ON-SITE SEWAGE DISPOSAL SYSTEM
HOWARD COUNTY HEALTH DEPARTMENT
BUREAU OF ENVIRONMENTAL HEALTH

SUBDIVISION: Clarksville Meadow LOT NUMBER: 7

ADDRESS: 7020 Guilford Road PROPERTY OWNER: Steve & Lisa Rosenthal

BUILDER: SELFRIE BUILDERS, INC. 14045 GARED DRIVE GLENWOOD, MD 21738 410-531-8930	PROJECT: CLARKVILLE MEADOW LOT 7
PROPERTY: 7020 GUILDFORD ROAD CLARKVILLE, MD 21029	LOCATION: TAX MAP 35, GRID 21, PARCEL 296 5th ELECTION DISTRICT HOWARD COUNTY, MARYLAND
DESIGN: JC	TITLE: PERMIT PLAN ROSENTHAL RESIDENCE
DRAFT: JC	DATE: NOVEMBER, 2004
CHECK: DAM	PROJECT NO.: 1772
SCALE: AS SHOWN	SHEET: 1 OF 1

WALL CHECK
CLARKSVILLE MEADOWS
SECTION ONE AREA ONE
LOT No. 7

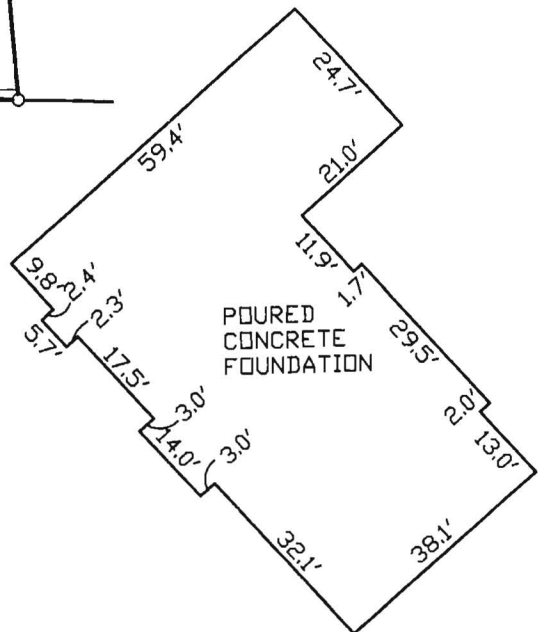
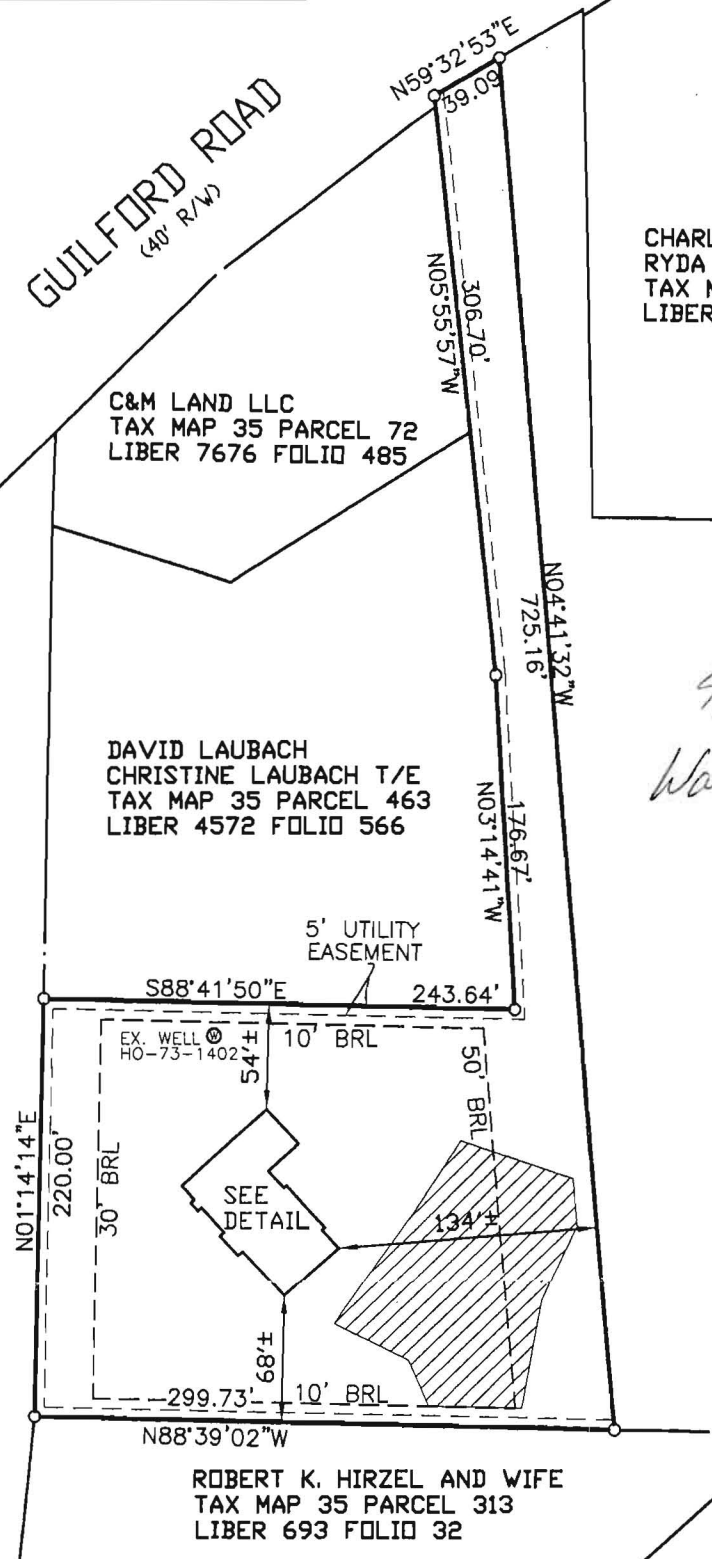
4/13/05
Wall check OK
(KJB)

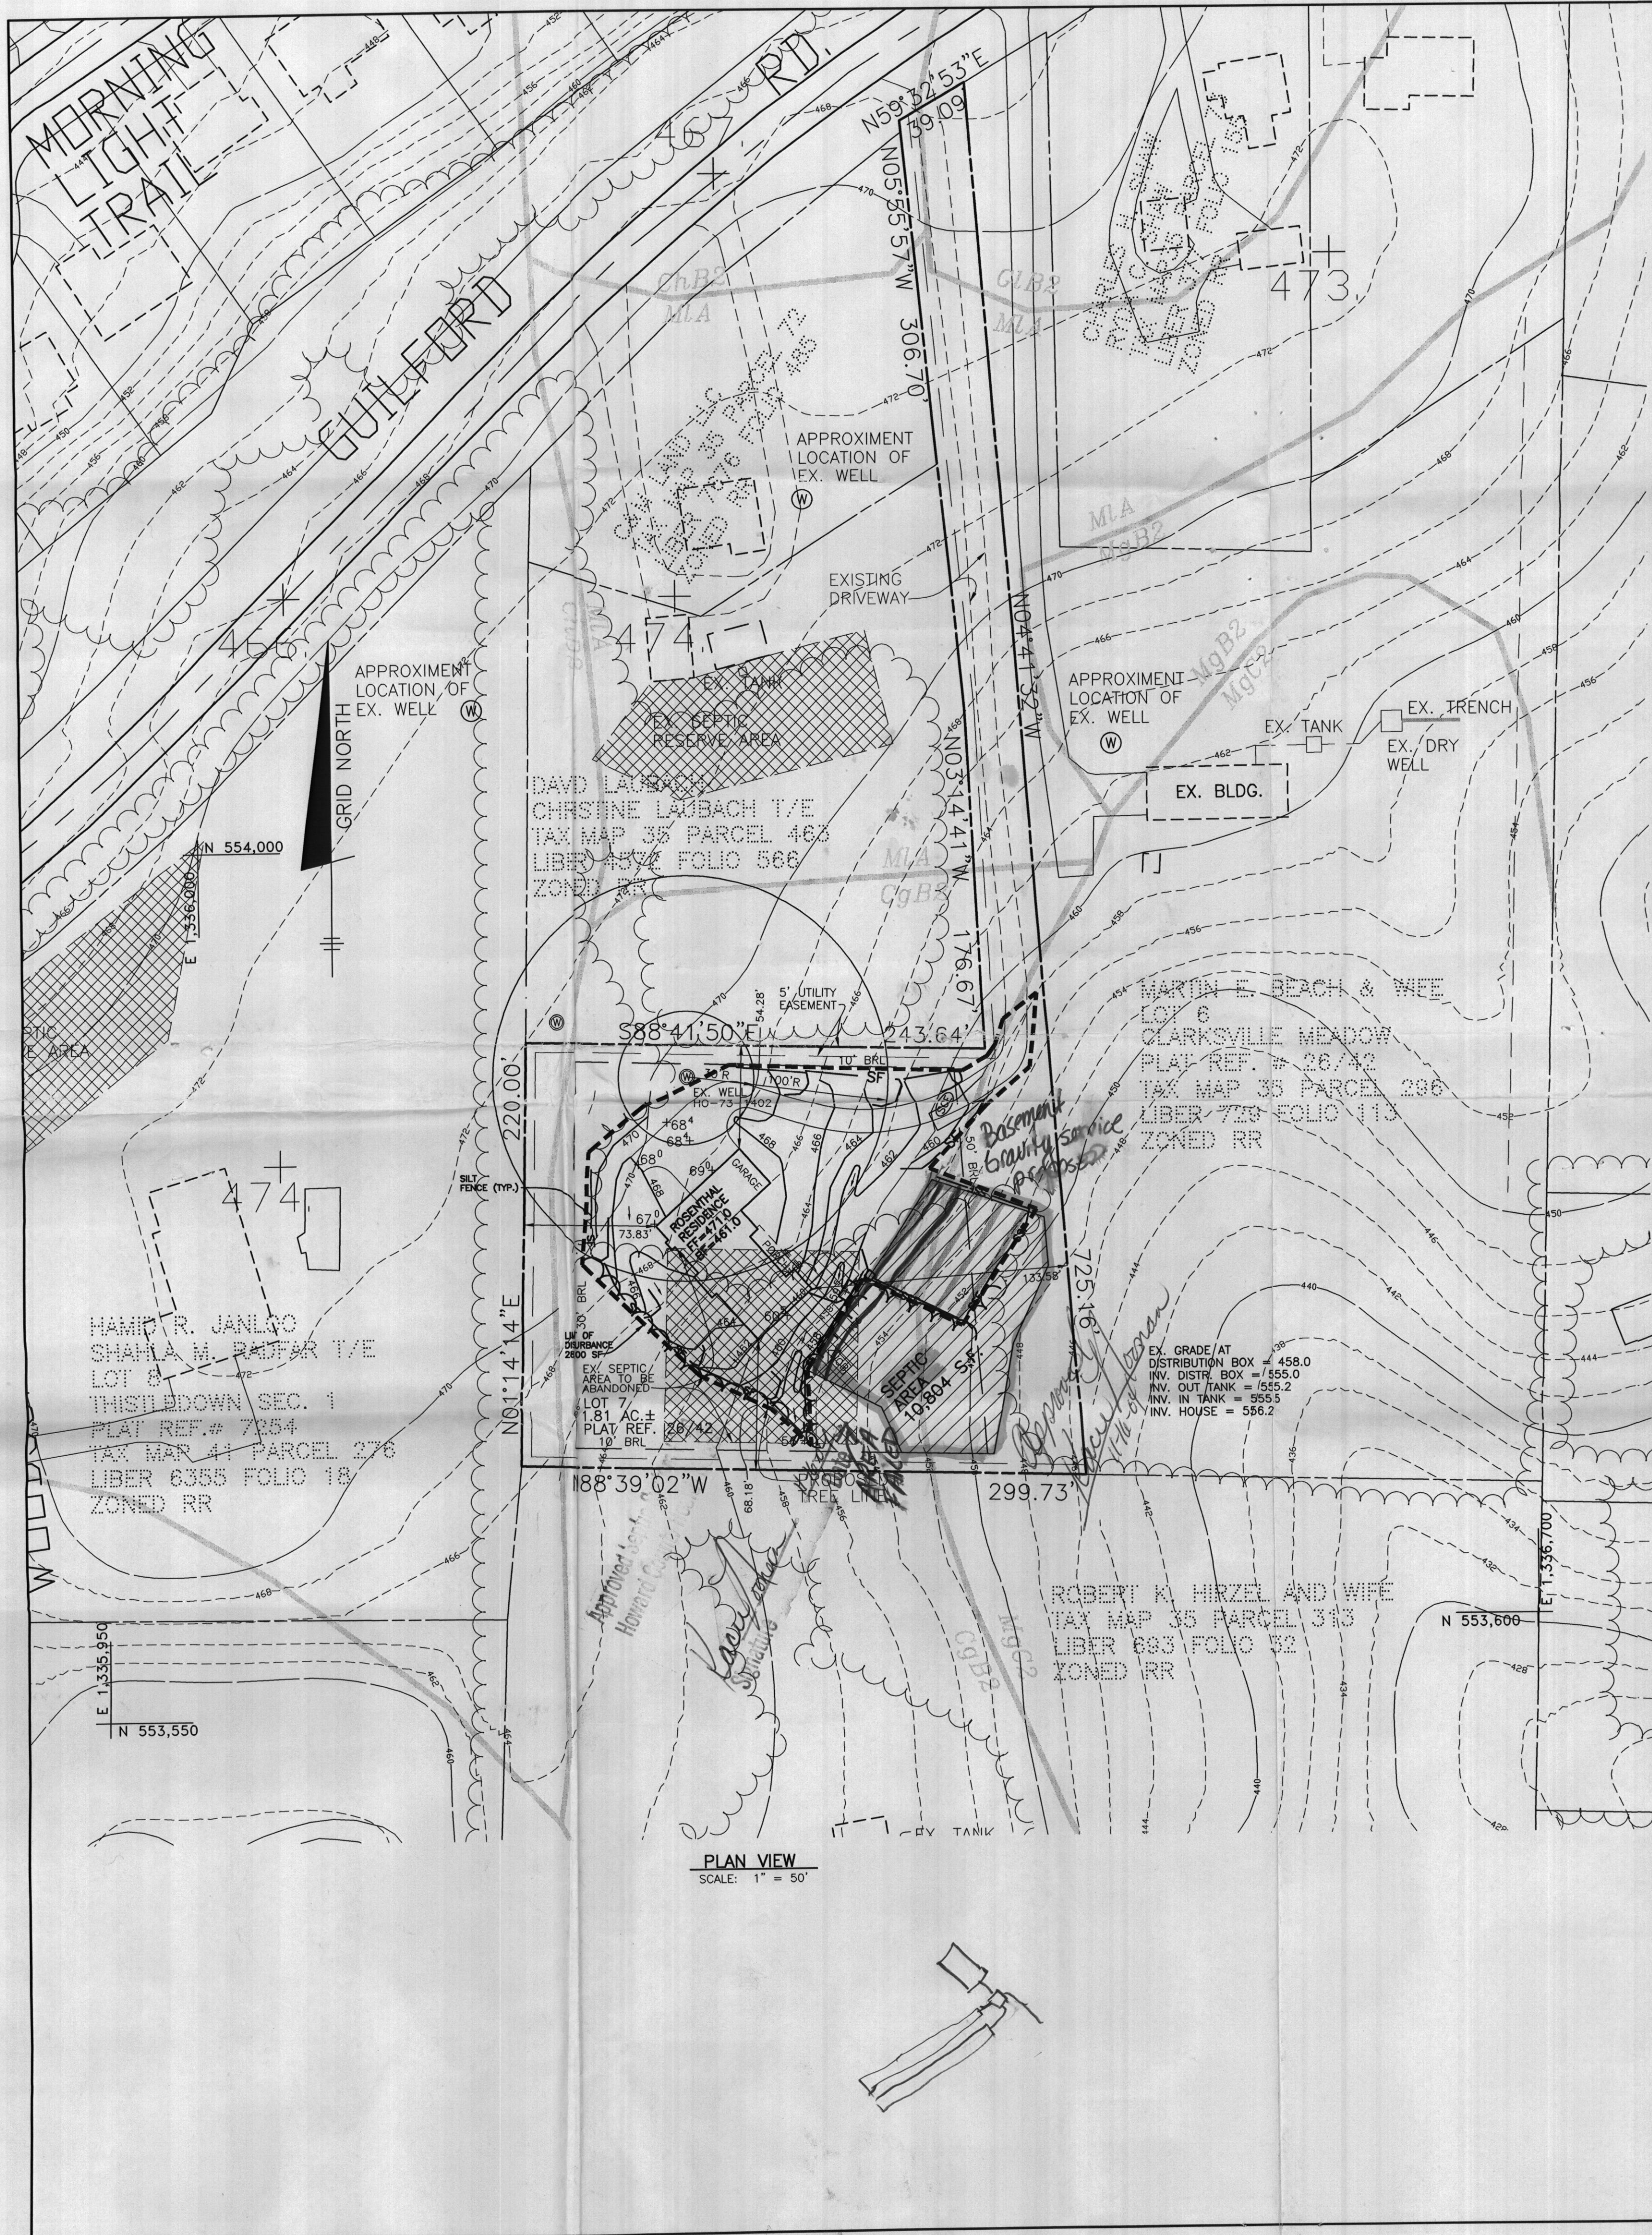
Recommend applicant have to/13/14
hit some clay due to nearby swale
Frost OK, altho may
Ex: well OK subject to yield
proposal
Re-Demo/Re-build
w/ c. w/ m
Ragen
1/15/04
